Report: TAB Report
Function: Test, Adjust, & Balance
Date: 02/09/2026
Completed By: National TAB

PROJECT
02-09-26 QT #0432 PHOENIX, AZ

Project: 02-09-26 QT #0432 PHOENIX, AZ

Project Issue Information

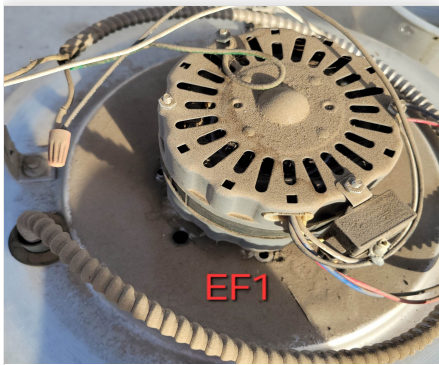
Issue Name : EF1 NOT RUNNING
Description : EF1 is not running at all, does not have a shut off switch, and does not have a motor speed controller installed.
Created By : National TAB **Assigned To :** National TAB - Dan Hertenstein
Status : Open
Priority : Urgent **Asset Tag :** EF1
Originated Date : 02/11/2026 - Christine Weale - National TAB

Project Issue Information

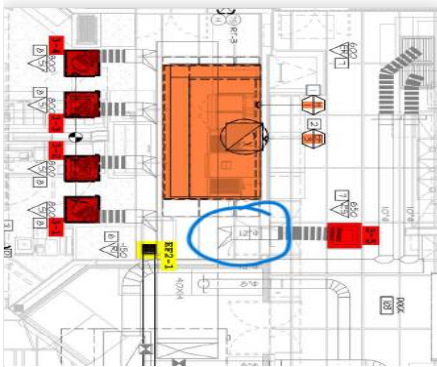
Issue Name : EF2 - NO MOTOR SPEED CONTROLLER
Description : EF2, exhaust for the men's RR, also does not have a motor speed controller installed. It is running too low and cannot be balanced.
Created By : National TAB **Assigned To :** National TAB - Dan Hertenstein
Status : Open
Priority : Urgent **Asset Tag :** EF2
Originated Date : 02/11/2026 - Christine Weale - National TAB

Project Issue Information

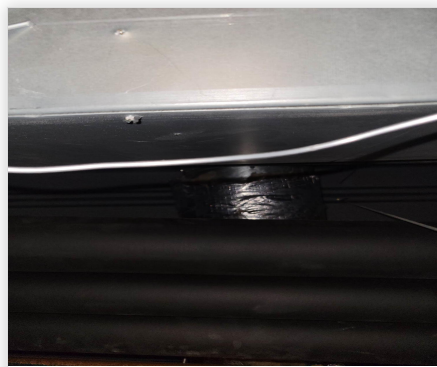
Issue Name : INACCESSBILE DAMPER
Description : SGRD3-5 is not installed per GRD and the duct goes over the supply and somewhere past the supply instead of coming from it, therefore damper is inaccessible (no tiles to move to see where it goes).
Created By : National TAB **Assigned To :** National TAB - Dan Hertenstein
Status : Open
Priority : Medium **Asset Tag :** SGRD3
Originated Date : 02/11/2026 - Christine Weale - National TAB
